RE: PCN # ESU270-29 -- SR70-02CTG Alternate Manufacturing Location Approval for Wafer Foundry & Backend Assembly, Test and Packing

## Product/Process Change Notice (PCN)

# PCN Report

#### 3.2 Material Changes

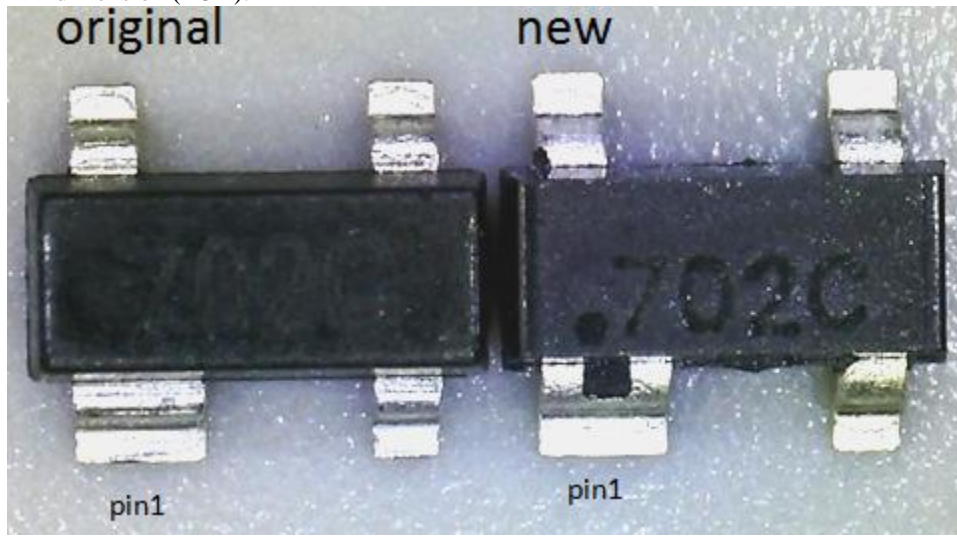
Material	SR70-02CTG				Changed?
	Original		New		
	Material Name	Supplier	Material Name	Supplier	
Leadframe	YEF-42	XMYH	A42	PSMC	Yes
Die Attach Material	84-1LMISR4	HENKEL	84-1LMISR4	HENKEL	No
Au Wire	30um	HERAEUS	30um	HERAEUS	No
Molding Compound	ELER-8-100HFE	E'DALE	G600	SUMITOMO BAKELITE	Yes
Lead Finish	Matte Tin	Yunnan	Matte Tin	REDRING SOLDER (M) SDN. BHD.	Yes
Wafer	333DA		LFSR03A LFSNR01A		Yes

Pin1 appearance is changed. The other dimensions are no change in mechanical specification or package outline dimension (POD).
